Subject: Concord Steam Facility Condition Survey Follow Up Report

References: Electrical Safety Report, Revision 1, August 5, 2016 by Nowland Services, PLLC

RE: Division of Public Works Design and Construction Report, December 9, 2016
Concord Steam Plant
Concord, NH

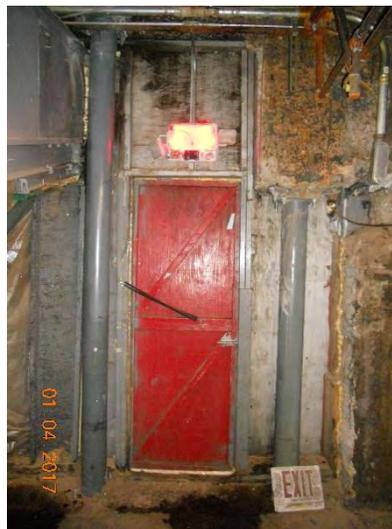
Turbine Room West: The original condition survey found an area in the roof with deteriorated wood plank and beams. Our follow up inspection found that the deteriorated wood decking in the false ceiling was removed as requested. In addition, to reinforce some deteriorated wood timber, W6X15 beams were added, framed on top of the W12X30 support beams. The photo below documents this installation. This was installed in lieu of the original recommendation of the installation of a new W12 beam. The framing that was installed is structurally adequate to support the deteriorated wood plank.
